City of Portland, Maine – Building or Use Permit Application 389 Congress Street, 04101, Tel: (207) 874-8703, FAX: 874-8716

BUILDING PERMIT REPORT

DATE: 13 February 1999 ADDRESS: 17-19 3rd ST, Proposed P.I.C.B.L. 85-S-4 & 5
REASON FOR PERMIT: Addition Renovation work (See permit application)
BUILDING OWNER: G. & M. Strout
CONTRACTOR: McTigue Construction
PERMIT APPLICANT: owner
USE GROUP R-3 BOCA 1996 CONSTRUCTION TYPE 5-B

Foundation Plan

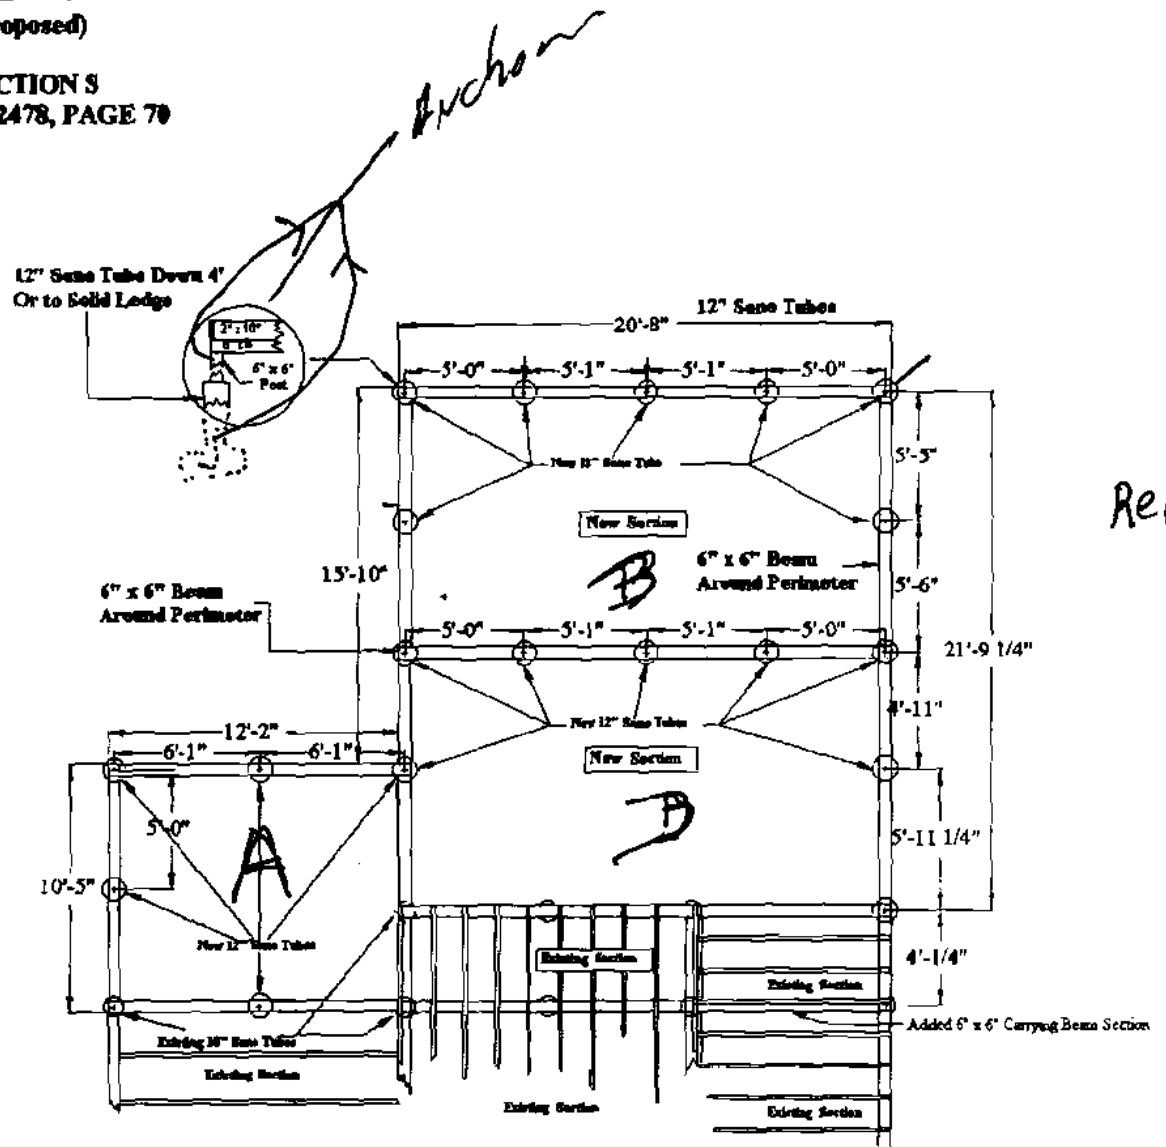
- 2.6 Foundations anchors shall be a minimum of 1/2" in diameter, 7" into the foundation wall, minimum of 12" from corners of foundation and a maximum 6' o.c. between bolts. (Section 2305.17) *The proposed foundation (5020 tubes piers) must be placed on footing with anchor between the two - The foundation piers must have anchor between pier and wood fr.*
